Appendix 3: Natural Features and Landscape Report – James Bentley

IN THE MATTER District Plan Hearing concerning:
Natural Features and Landscapes
Chapter

STATEMENT OF EVIDENCE OF JAMES ARTHUR BENTLEY

1 June 2022

Figure 1: Excerpt of PDP of 11 Colletts Road. Green

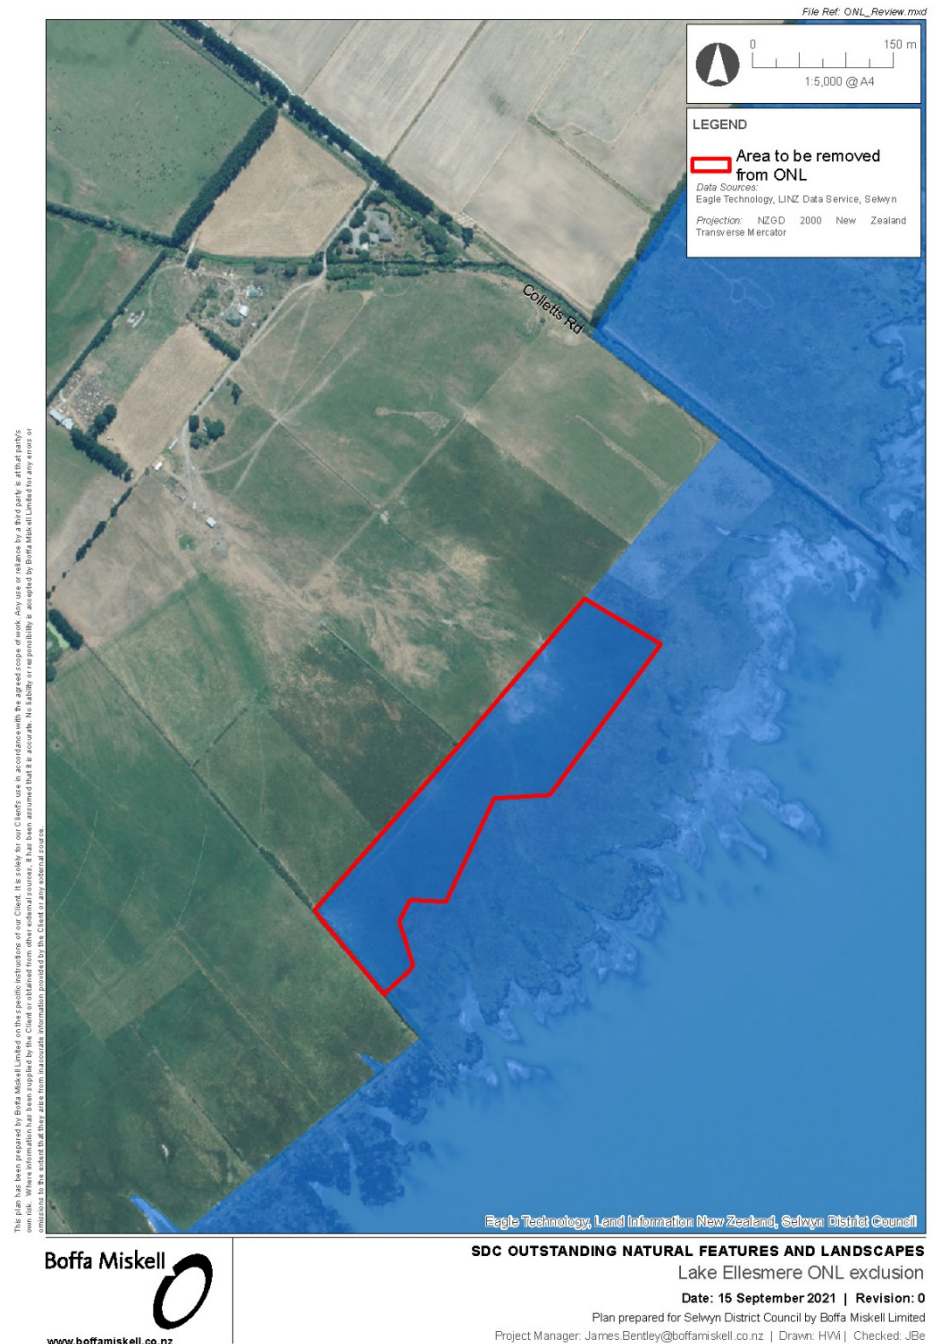
7.1 Request: 'Amend the Outstanding Natural Landscape boundary to match the fence line at 11 Colletts Road (which appears to be legally described as Lot 7 BLK X RES 959 BLK III Southbridge SD), near Leeston'.

- 7.2 The above Figure illustrates the location of 11 Colletts Road in relation to the ONL of Lake Ellesmere. The extent of the ONL as it relates to Te Waihora/ Lake Ellesmere has been principally guided by the impact of more intensified land use activities. Modification around the lake has limited the extent to which the lake's natural margins extend. Where land is more modified, which has affected the landscape values associated with the lake's margins, these

- 7.3 I have carefully reviewed the extent of the ONL in the immediate vicinity of this property. The extent of the ONL has endeavoured to follow logical features on the land, such as areas of vegetation. Where no natural feature has been followed, fence lines and paddock boundaries have been used. In this case, I followed an apparent fence line with vegetation associated with it. I have reviewed this and consider that a more refined boundary could be applied to the fence line mentioned by the submitter. This would avoid including a small area of managed pasture.

- 7.4 To accept this submission and to slightly realign the boundary of the ONL on this property, as mapped.

Figure 2: I recommend to change the orange line to better follow the northern extent of the Rakaia River (as it is drawn to the immediate south) so that land becomes part of the Rakaia Catchment ONL.

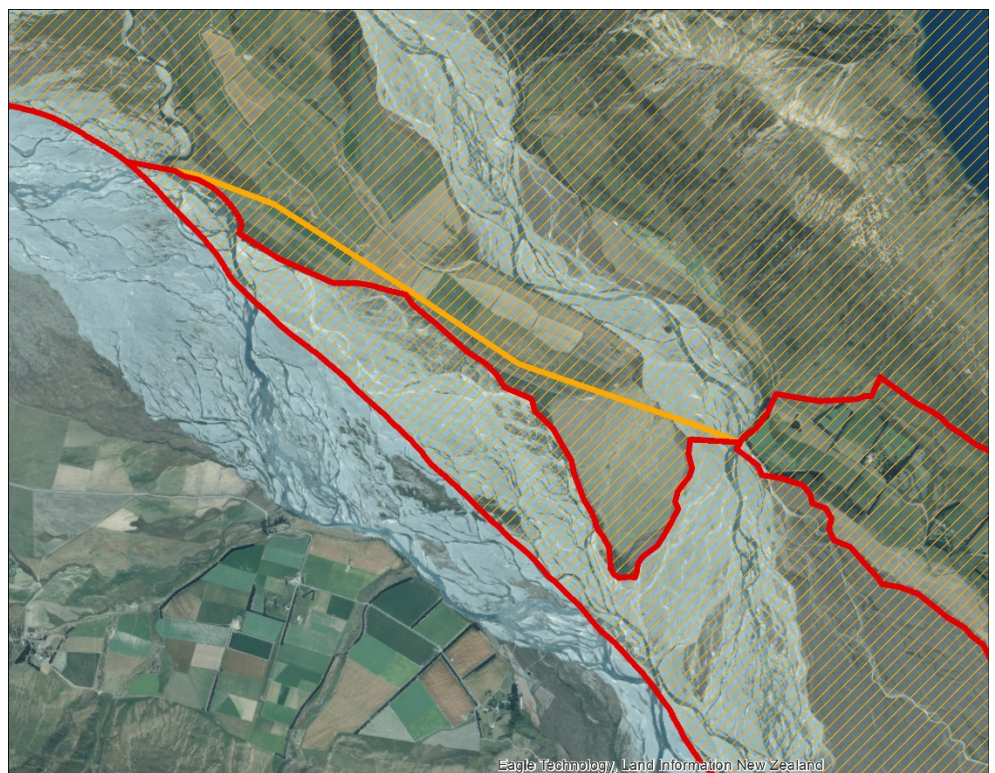
7.10 These submissions concern High Country Stations. Submission 0104-001 concerns Mt White Station and Submission 0144-001 concern a group of five high country stations. Specifically, these submission points requests that the ONL (as proposed) be removed and in the instance of The Stations, that the ONL overlays as they relate to the current Operative SDC Plan, be retained.

- 7.15 Through the development of the provisions that relate to these high country ONLs, it is my understanding that these have been carefully crafted to enable existing farming activities to continue, irrespective of the ONL overlay. I support these provisions.
- 7.16 Specifically concerning the relationship between the Rakaia River ONL and the Rakaia Catchment ONL, I have reviewed how these areas interrelate and made some amendments to their boundaries close to the Mt. Algidus Station. The Rakaia River ONL now better follows the River (rather than partly drifting over land).

- 7.17 To amend the Rakaia River ONL boundary to better follow the Rakaia River. To reject the remaining submission points.

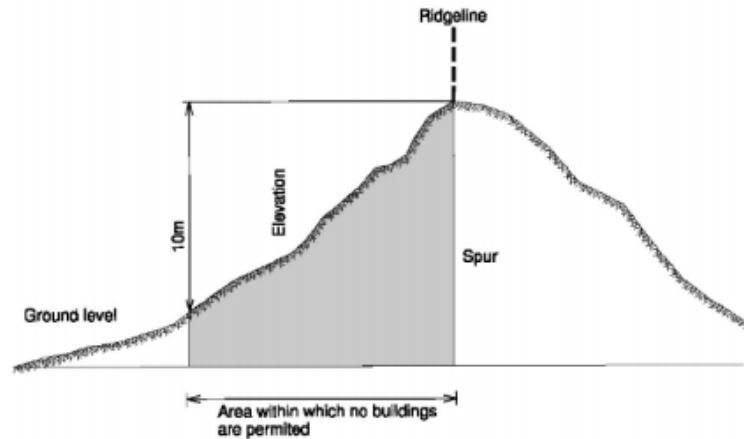
7.21 The submission considers that no definition of 'ridgeline' has been included in the proposed District Plan. This may cause uncertainty within the Plan given that some provisions rely on the term to determine compliance with the Plan. The submitter recommends that the following could be inserted in the policy: *'A geological feature that has a continuous elevational crest for some distance; provided that for the purposes of landscape assessments. This does not include the vegetation on the ridgeline'*.

7.22 I understand the concern although the wording suggested, in my view is not clear. I offer the following definition (and accompanying diagram), which has been used in other districts:

‘Ridgeline is the line marking or following the ridgetop that forms a continuous elevated crest and is the line of intersection at the top of opposite slopes’.

- 7.23 To accept in part the definition as suggested.

Figures 3A: Current (top), amended (below). North-West of Te Waihora/Lake Ellesmere. Orange linework ONL; yellow linework = coastal environment and yellow shading = high natural character.

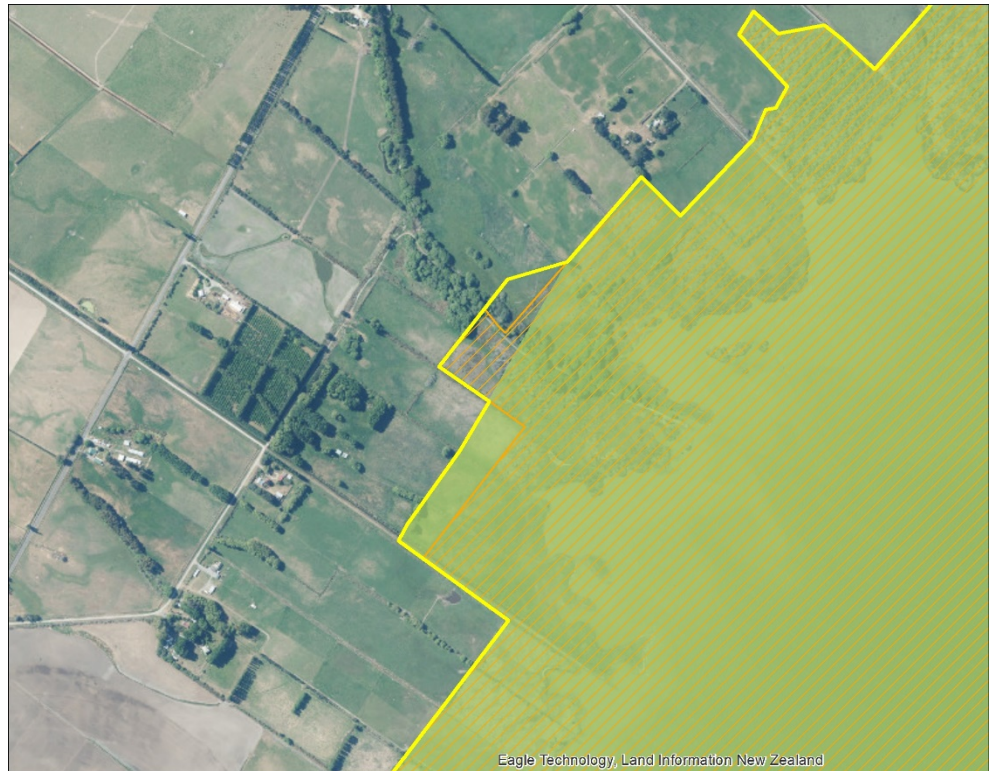
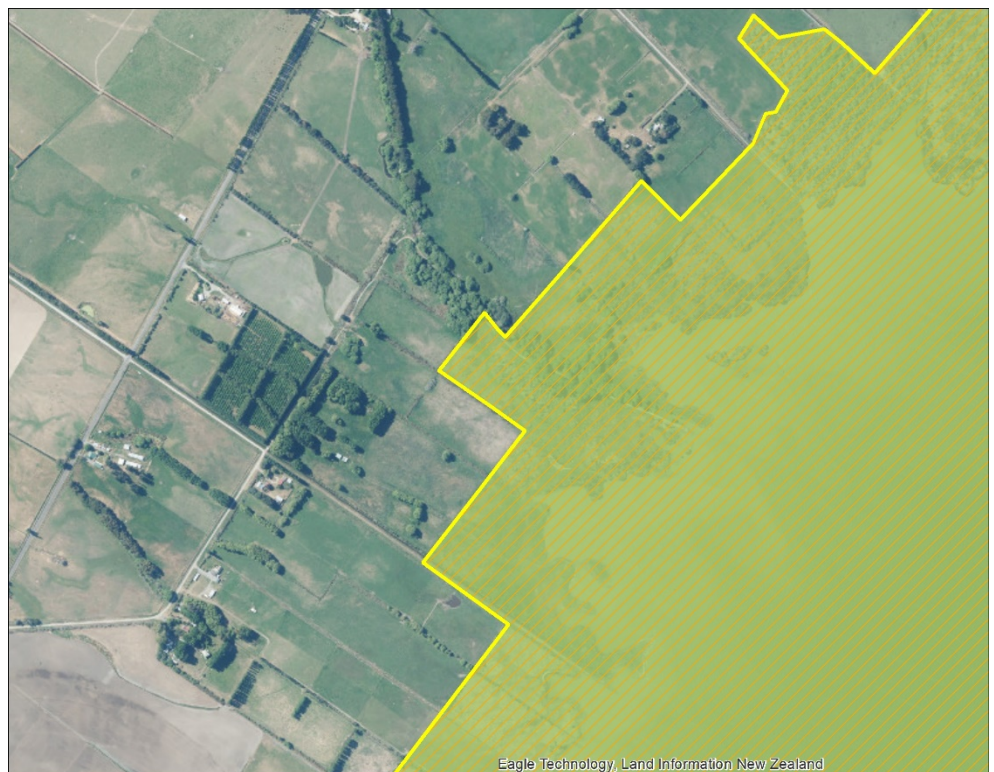
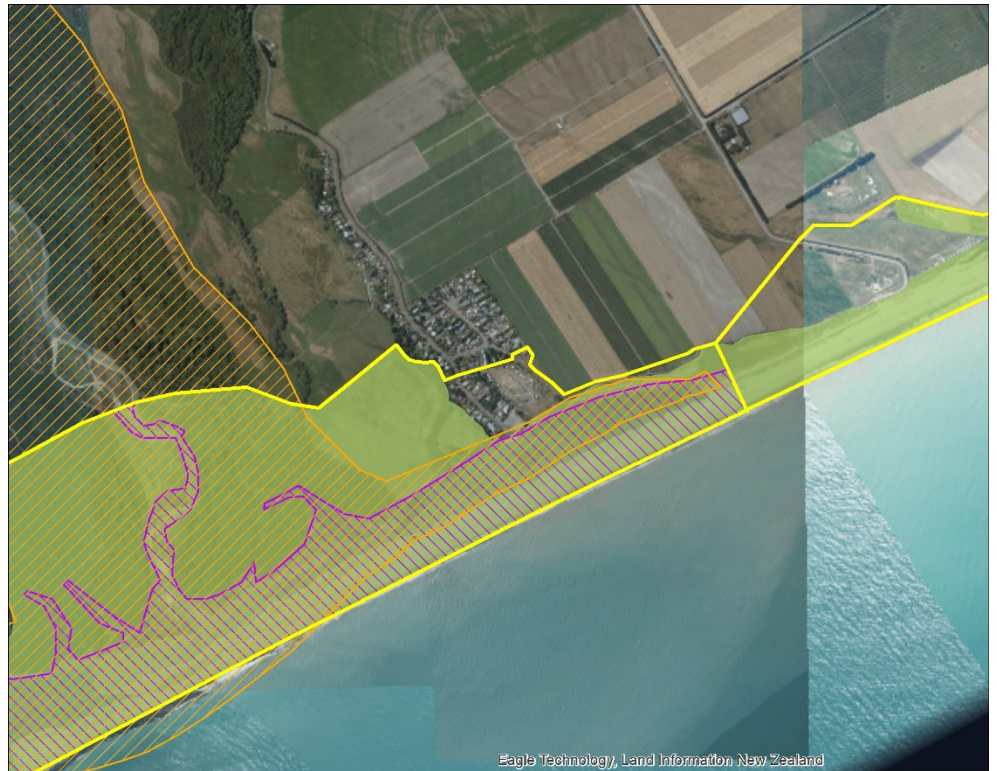
- 7.28 Ellesmere Sustainable Agriculture Incorporated seek the rationalisation of different overlays¹¹ where they overlap, particularly in their area of interest which is around the environs of the Rakaia and Selwyn River mouths and Te Waihora/Lake Ellesmere
- 7.29 I have reviewed the overlays in relation to the Rakaia and Selwyn River mouths and Te Waihora/Lake Ellesmere and agree that some rationalisation can occur, most notably where the values are inextricably entwined and the linework slightly deviates. Of course, this is noting that the identification of the inland coastal environment boundary, the ONL and areas of high, very high and outstanding natural character are different, and retain a different methodology and in areas, the overlays do differ.
- 7.30 The snippets below illustrate a before and after scenario concerning amendments made

Figures 3B: Current (top) amended (below): Rakaia River mouth.
Orange linework ONL; yellow linework = coastal environment;
yellow shading = high natural character; purple linework =
outstanding natural character.

Figures 3C: Current (top) amended (below): Taumutu. Orange linework ONL; yellow linework = coastal environment; yellow shading = high natural character

Figures 3D: Current (top) amended (below): Timber Yard Point.
Orange linework ONL; yellow linework = coastal environment;
yellow shading = high natural character

7.31 I will issue SDC with updated GIS mapwork concerning this.
